**SUBMITTAL TO THE FLOOD CONTROL AND
WATER CONSERVATION DISTRICT
BOARD OF SUPERVISORS
COUNTY OF RIVERSIDE, STATE OF CALIFORNIA**

SUBJECT: FLOOD CONTROL DISTRICT: Approve Change Order, Contract Increase, and Notice of Completion for Ortega Channel Retrofit, Stage 91, Project No. 3-0-00070-91, District 1. [\$433,443 Total Cost - District funds 100%] (4/5 Vote Required)

Project Name: Ortega Channel Retrofit, Stage 91

CONTRACT CHANGE ORDER NO. 1

Exhibit 1 - Change Order 1

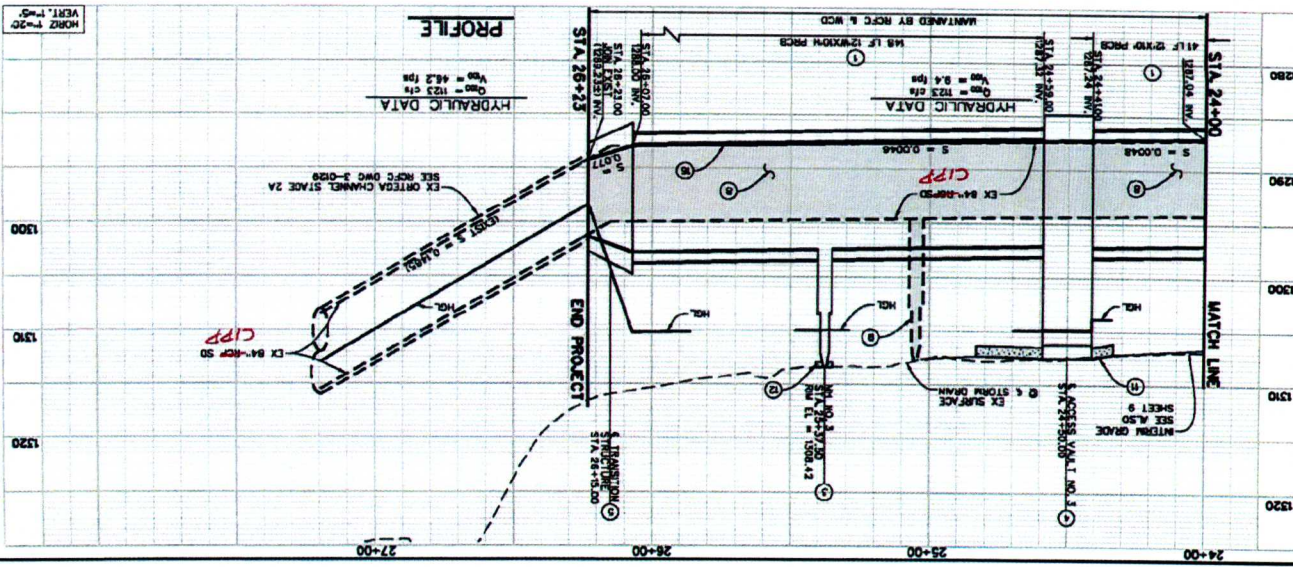
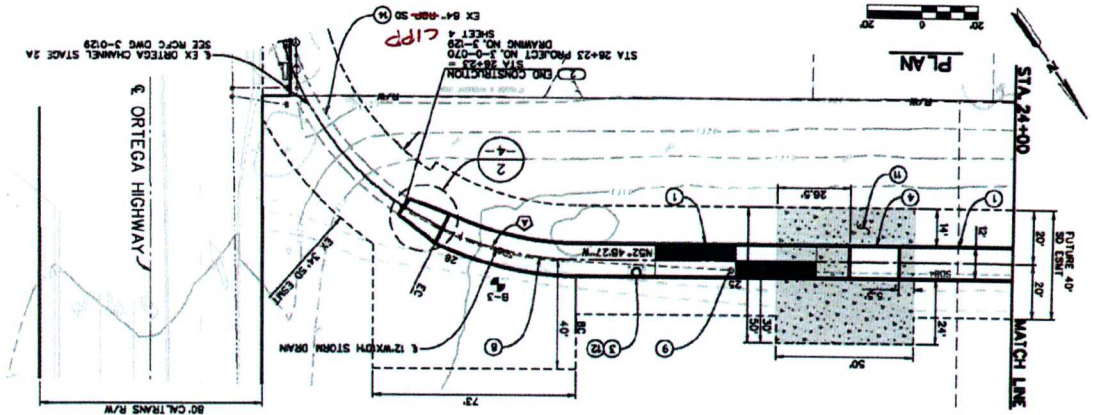
The Ortega Channel Retrofit, Stage 91 project (project) consists of demolishing an existing underground storm drain and replacing it with 12-feet by 10-feet precast reinforced concrete box. The contract documents showed the existing storm drain as a 'reinforced concrete pipe' (RCP). The District's Contractor, H&H General Contractors, Inc. (Contractor), began removal of the existing storm drain and discovered that the storm drain is of different character than what was shown on the plans. The storm drain is approximately 600 feet of cast-in-place pipe (CIPP) (see Exhibit 1, DWG 3-0215). The CIPP is approximately three times thicker than standard RCP and requires a substantial additional time and effort to remove and dispose. The change of conditions not only affects the time necessary to complete the work, but also changes the Contractor's intended means and methods for conducting the removal and significantly increases the quantity of material to be removed (see attached Photos 1 and 2). In good faith, the Contractor continued to work on the project and discuss a resolution for the Extra Work.

Exhibit 2, Ortega Channel Retrofit, Stage 91-Change Order No. 1 Extra Work Costs, includes the Extra Work line item descriptions and costs. Change Order No. 1 represents a lump sum change order that includes all additional labor, materials, equipment, equipment repairs, hauling, and debris disposal that is needed in order to complete all the extra work associated with the change in conditions from RCP as shown on the plans to CIPP. The total proposed compensation for the Extra Work is \$440,000 and an additional 30 working days.
